GENERAL NOTES (FOR ALL P&ID EDITS):

- A. DRAWING NUMBERS CHANGED
- B. CLOUDS DENOTE ADDITIONS/ MODIFICATIONS.
- C. NOTES USED FOR REMOVALS + ASSUMPTIONS.
- D. MAIN FLOWS, VALVE TYPES AND SIZES PRIORITISED.
- E. LINE NUMBERS STILL IN PROGRESS.
- F. INSTRUMENTS/ALARMS BASED ON MAINTENANCE LIST.
- G. HAND SWITCHES & FAULT ALARMS FOR ALL MOTORS.

ASPECT										TENNANT MINING					PROJECT: TENNANT MINING PTY LTD NOBLES NOB GOLD MINE				
THIS DRAWING IS THE PROPERTY OF ASPECT ENGINEERING SOLUTIONS PTY LTD AND IS PRIVATE, CONFIDENTIAL AND IS SUPPLIED ON THE EXPRESS UNDERSTANDING THAT IT IS NOT TO BE USED FOR ANY PURPOSE OR COMMUNICATED TO ANY OTHER PERSON WITHOUT THE WRITTEN PERMISSION OF THE PROPRIETORS.										TITLE: REAGENTS PIPING AND INSTRUMENTATION DIAGRAM					SHEET A1 SCALE NTS DRG No. NNGM-100-PI-005 REVISION 0				
REV										DATE					DESCRIPTION				
DRAW										CHECK					DESIGN				
TECH APP										PROJ APP					REFERENCES				
DRG No.

PROJECT: TENNANT MINING PTY LTD NOBLES NOB GOLD MINE			
TITLE: PROCESS WATER AND AIR SERVICES PIPING AND INSTRUMENTATION DIAGRAM			
SHEET A1	SCALE NTS	DRG No. NNGM-100-PI-012	REVISION 0

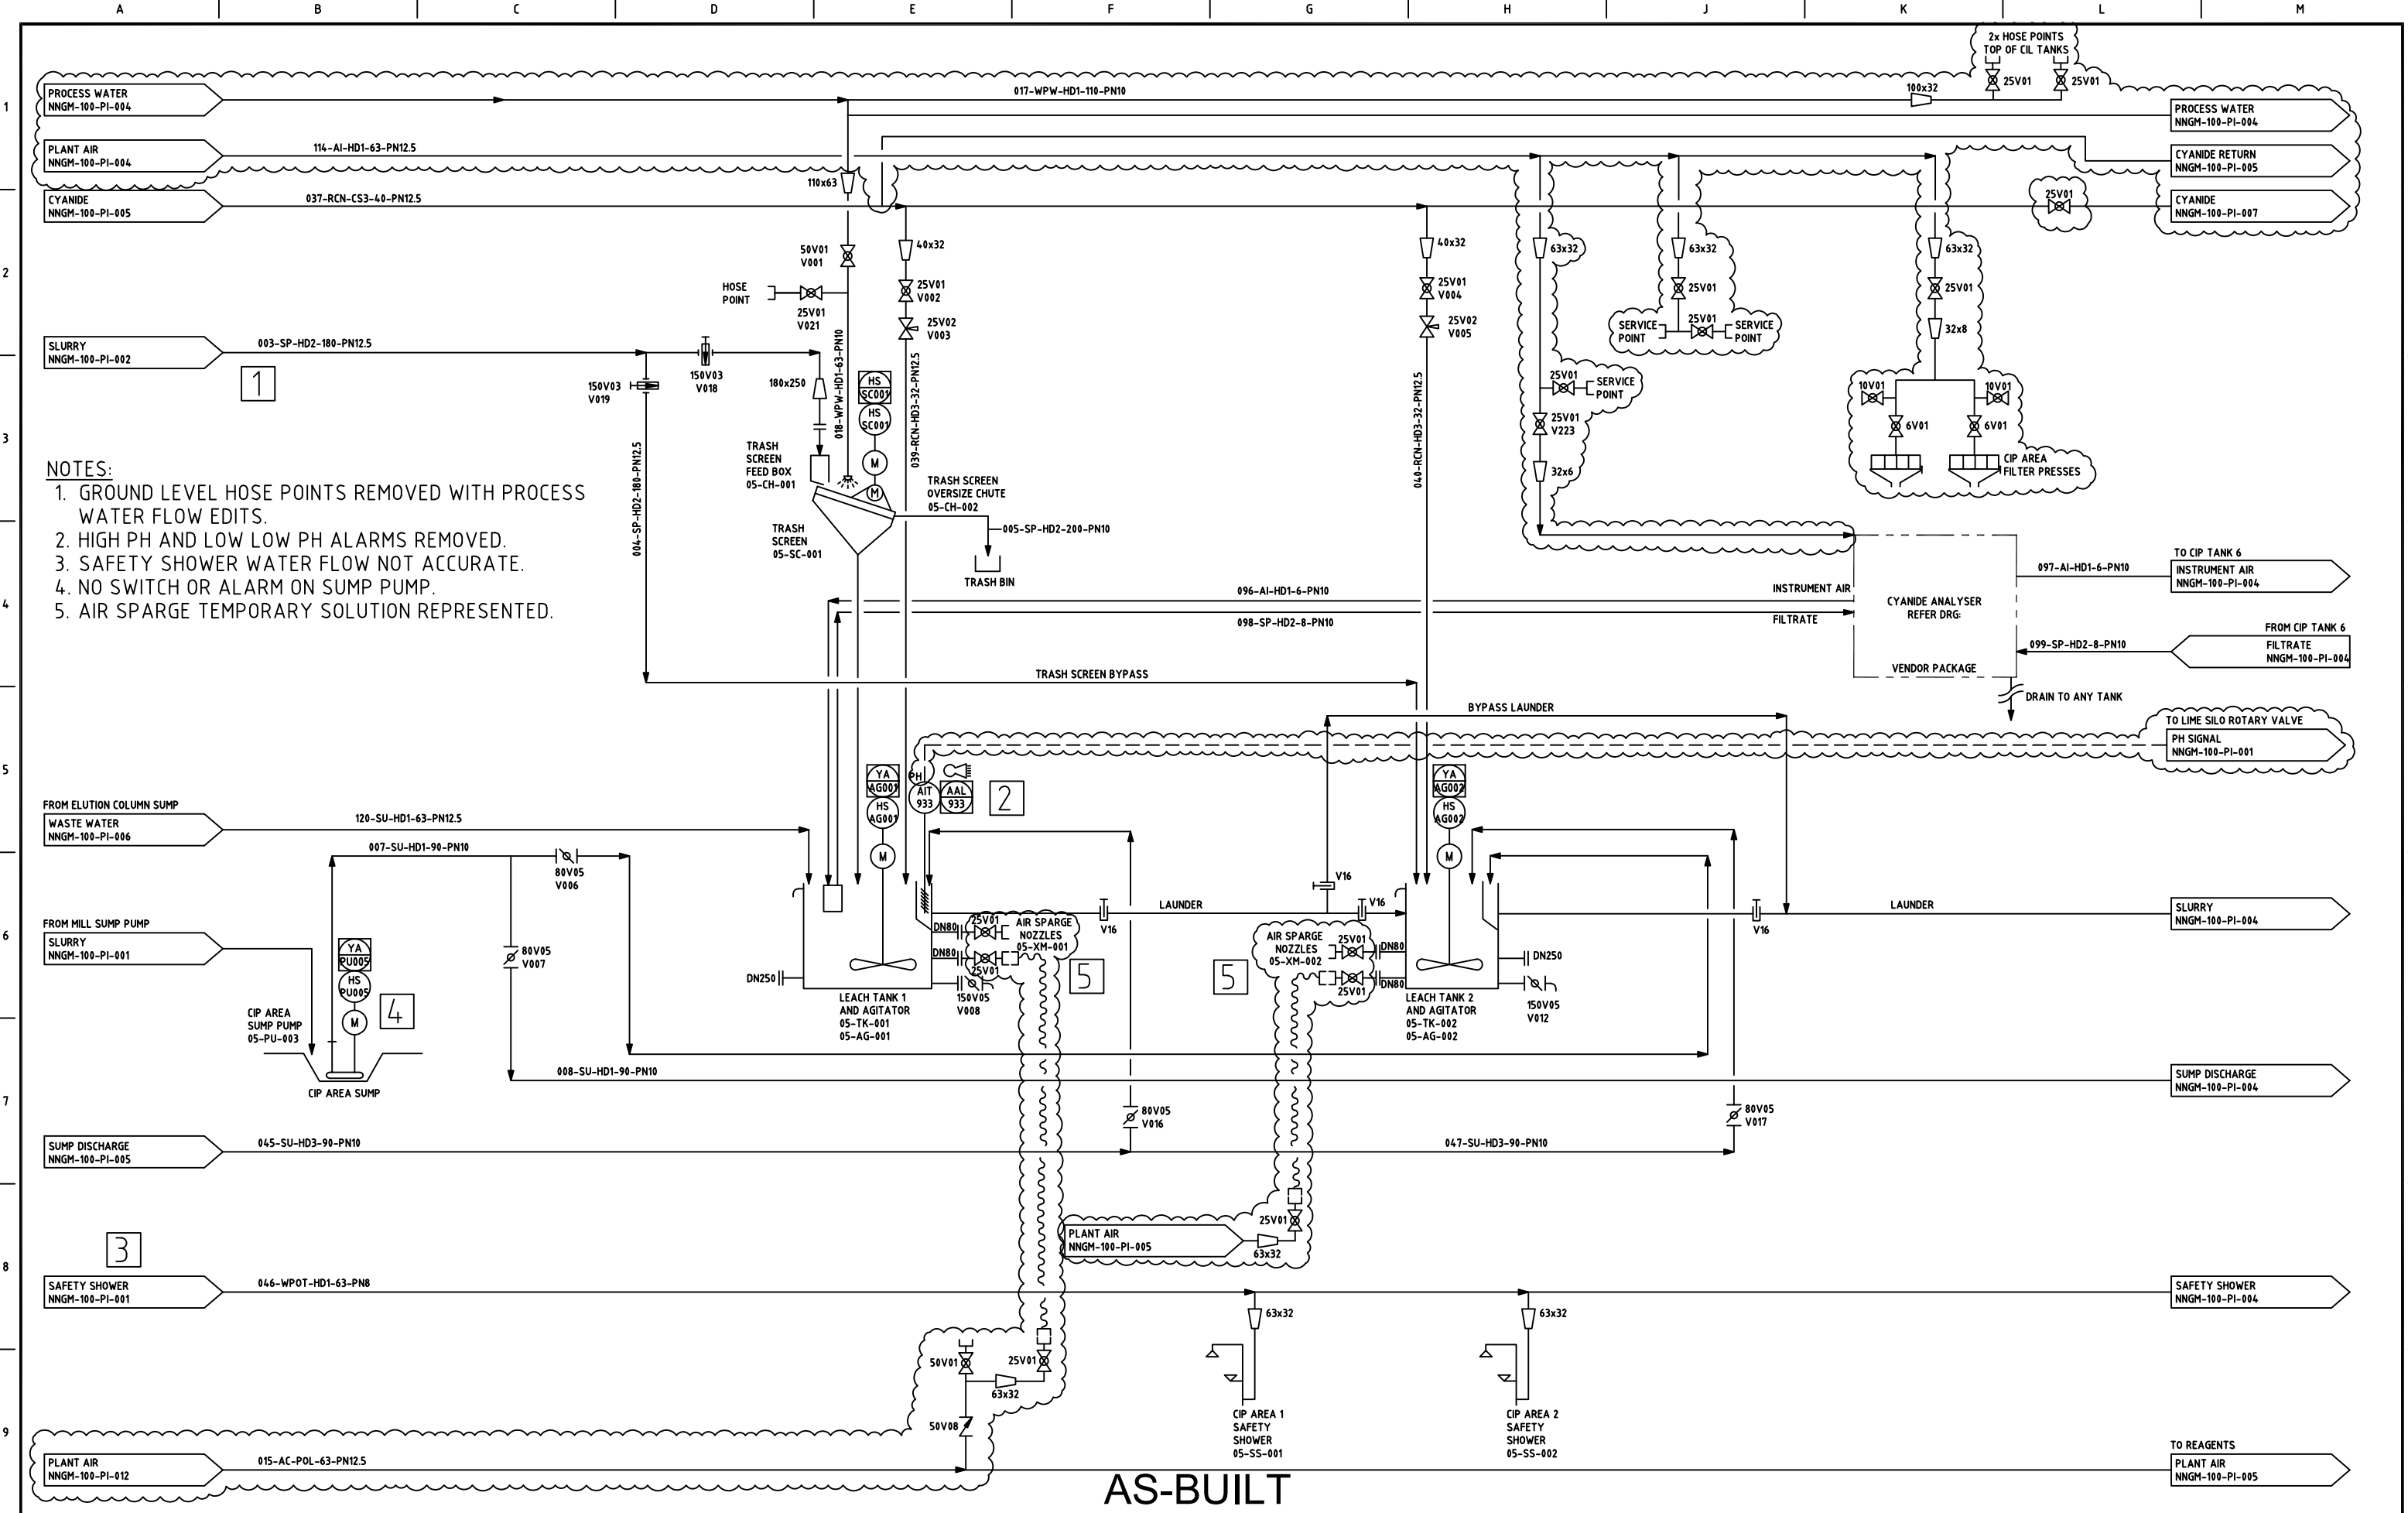
- NOTES:
1. GROUND LEVEL HOSE POINTS REMOVED WITH PROCESS WATER FLOW EDITS.
 2. HIGH PH AND LOW LOW PH ALARMS REMOVED.
 3. SAFETY SHOWER WATER FLOW NOT ACCURATE.
 4. NO SWITCH OR ALARM ON SUMP PUMP.
 5. AIR SPARGE TEMPORARY SOLUTION REPRESENTED.

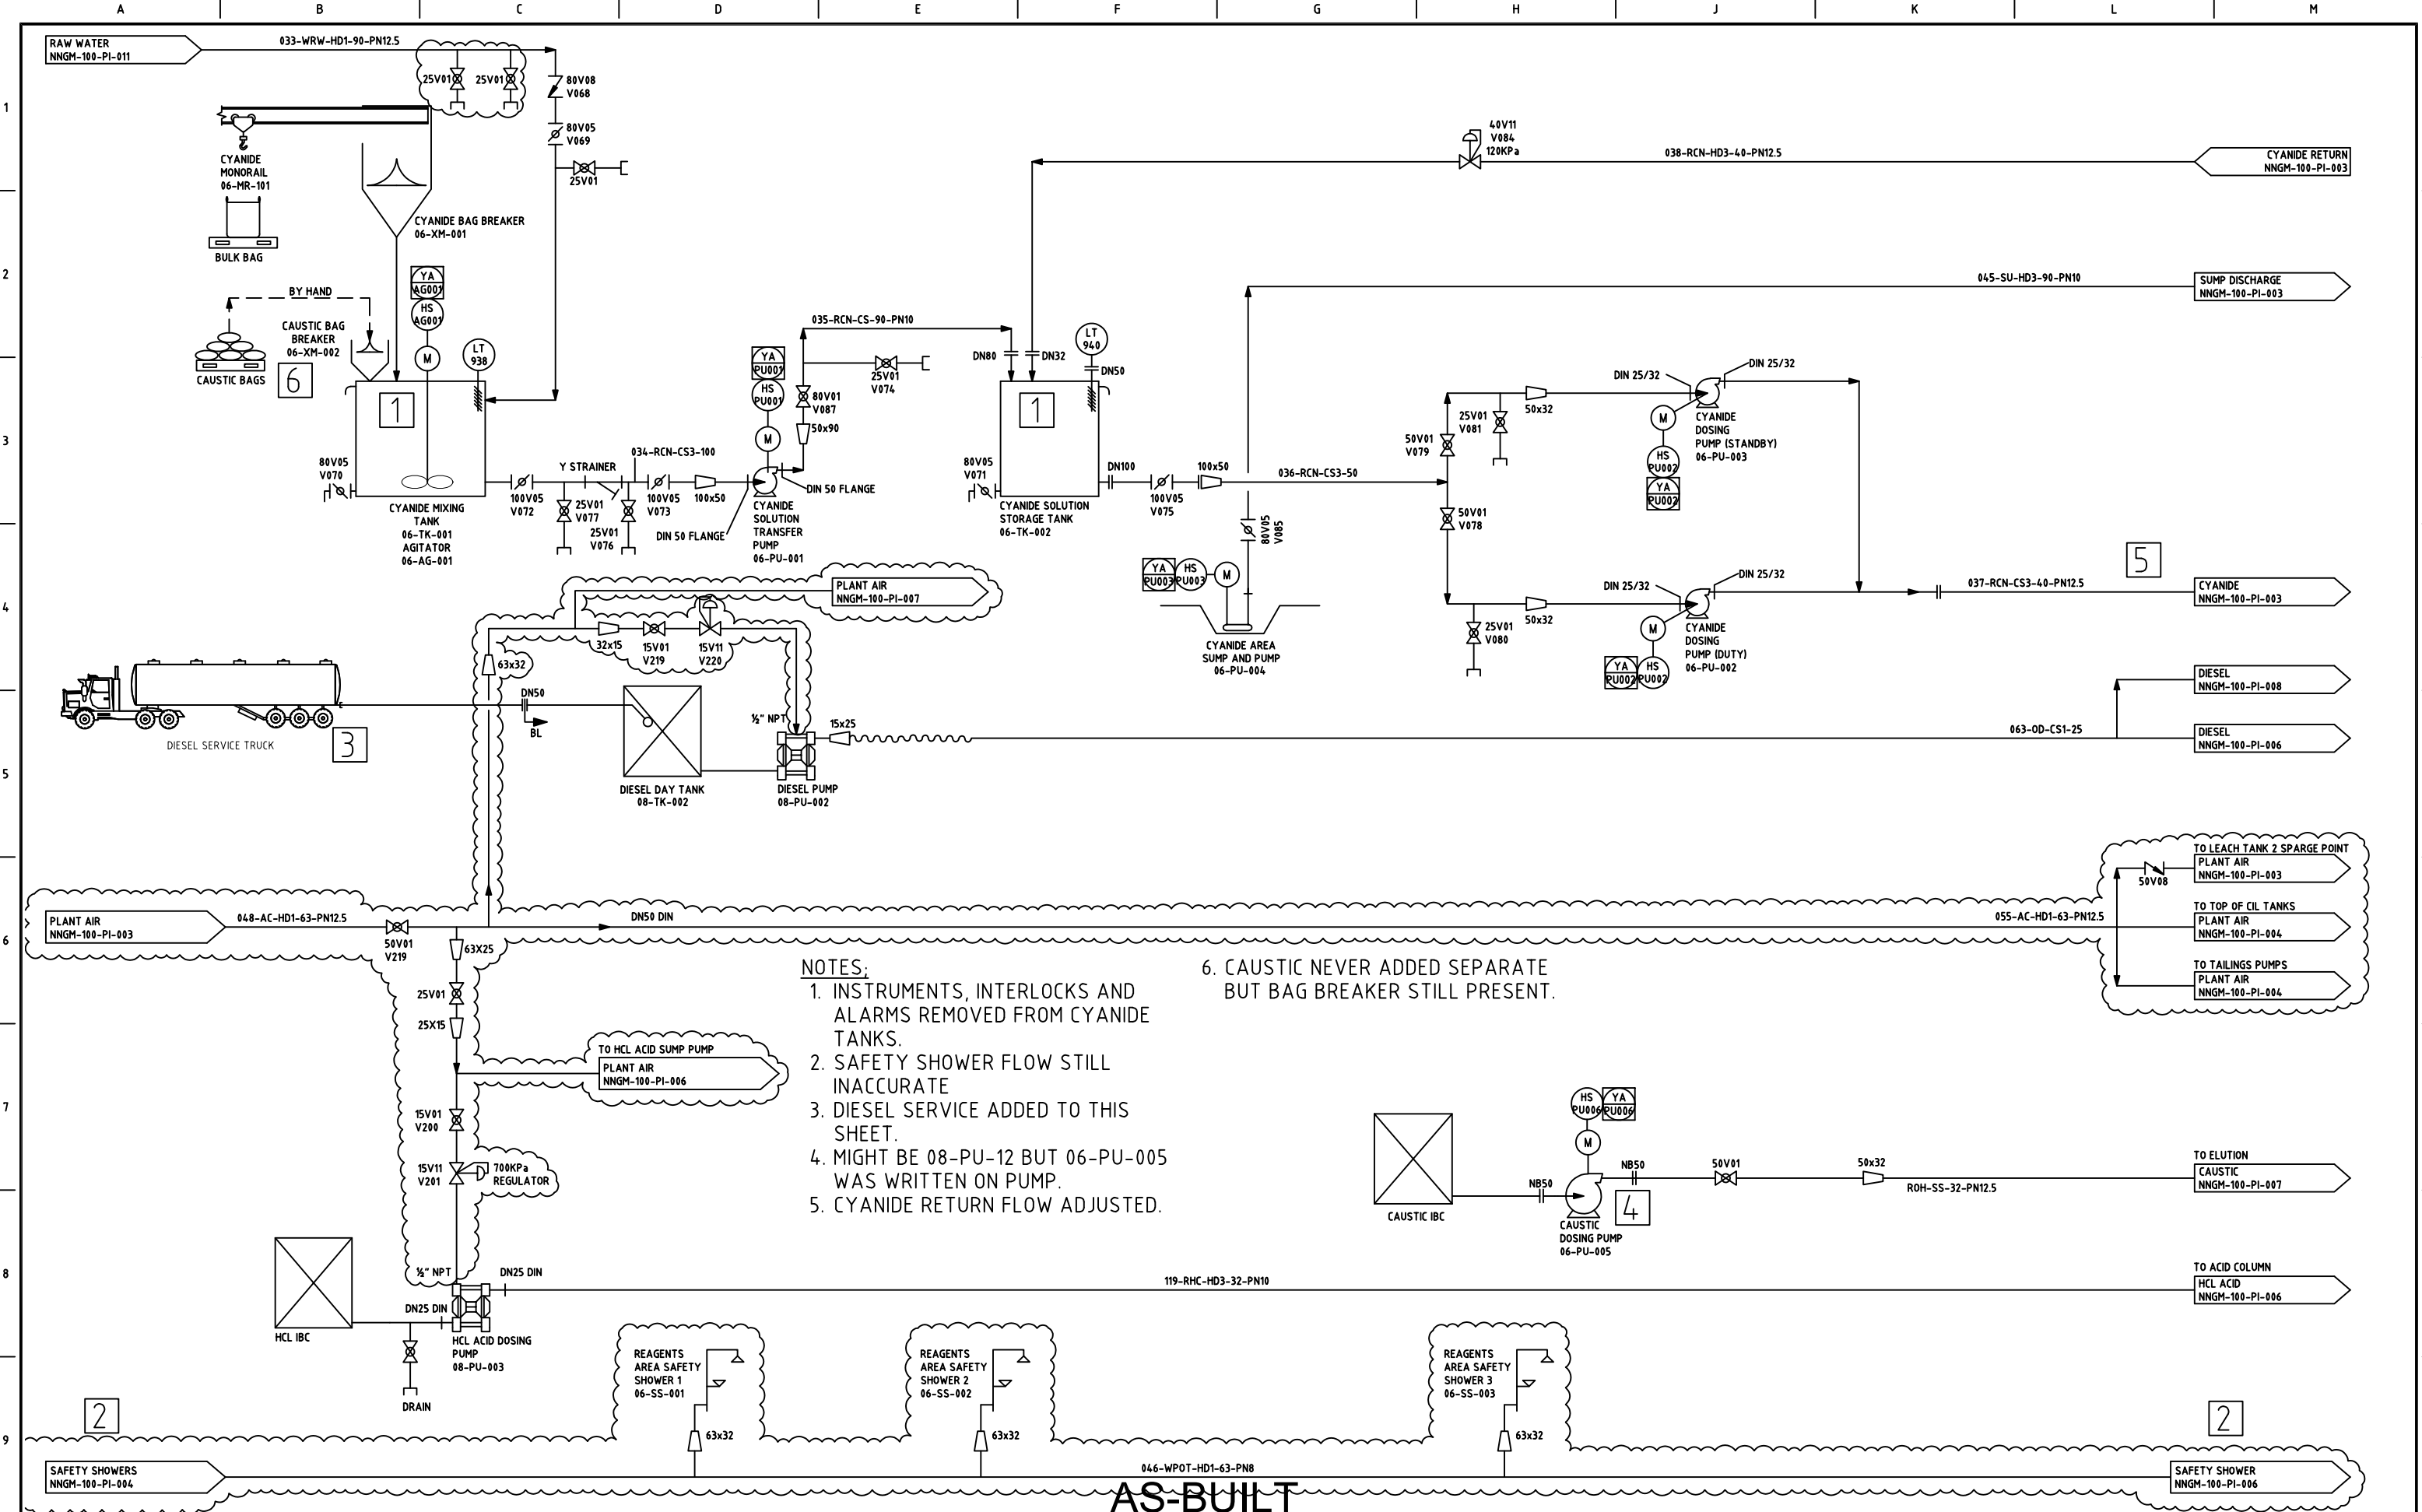
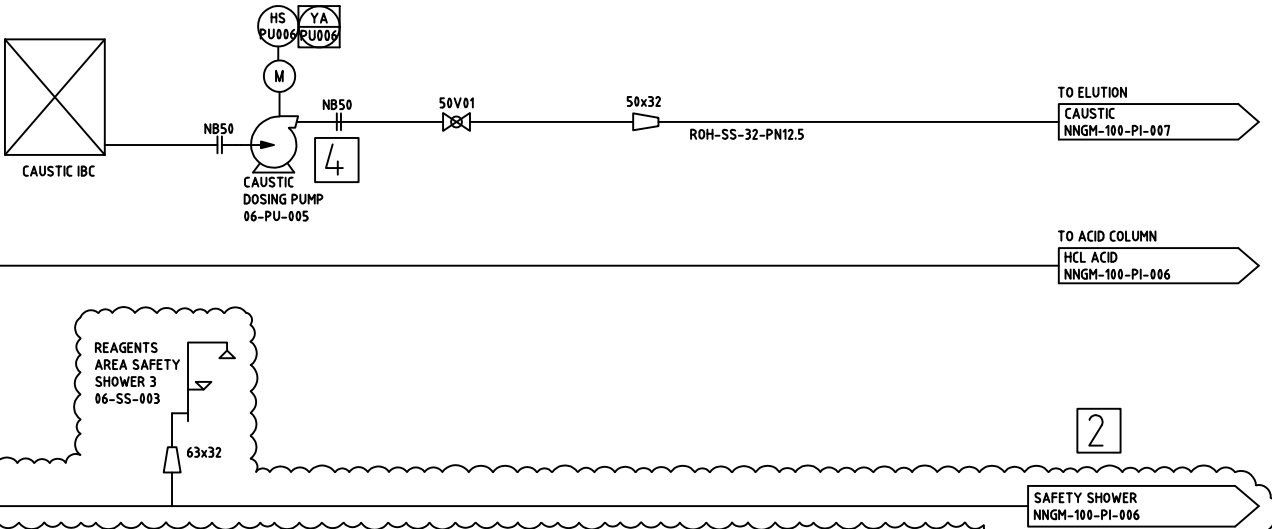
- NOTES:
1. INSTRUMENTS, INTERLOCKS AND ALARMS REMOVED FROM CYANIDE TANKS.
 2. SAFETY SHOWER FLOW STILL INACCURATE
 3. DIESEL SERVICE ADDED TO THIS SHEET.
 4. MIGHT BE 08-PU-12 BUT 06-PU-005 WAS WRITTEN ON PUMP.
 5. CYANIDE RETURN FLOW ADJUSTED.

6. CAUSTIC NEVER ADDED SEPARATE BUT BAG BREAKER STILL PRESENT.
